Conventional Fire Panel Interlink

Panel - A
(Fire Panel)

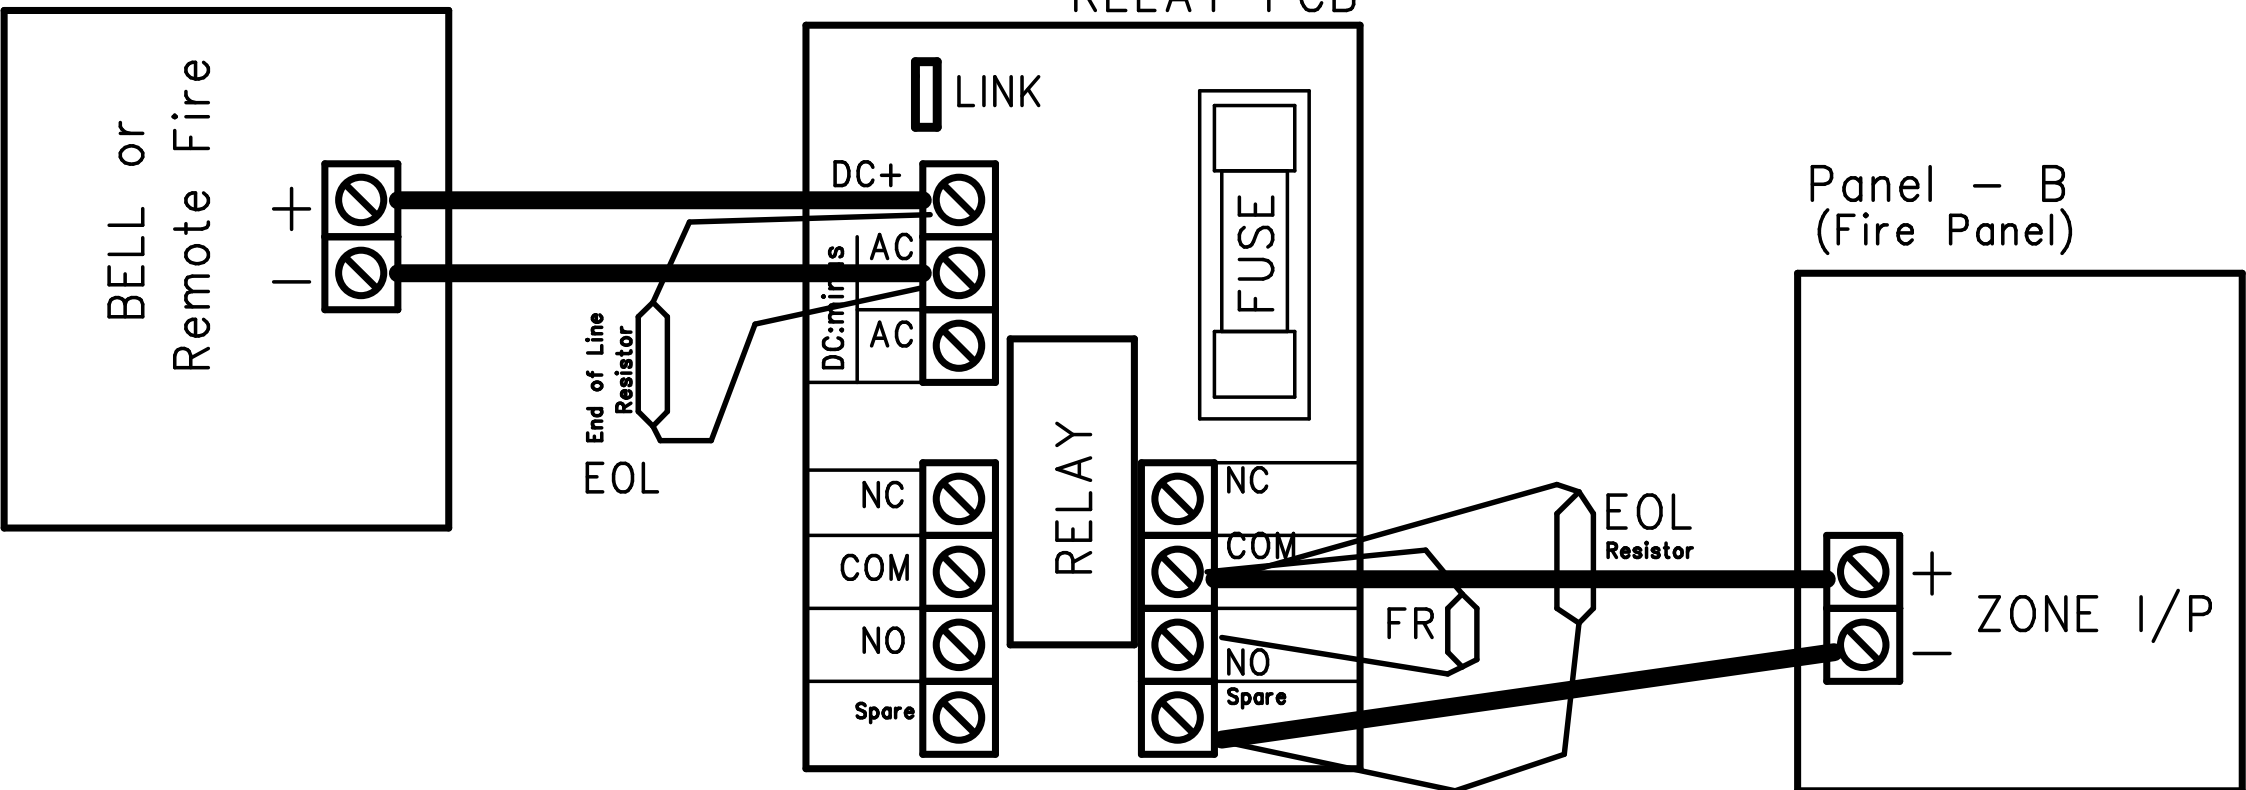
Remove 'LINK' to stop latch-up

Note: another relay is RQD. for panel-B to trigger panel-A
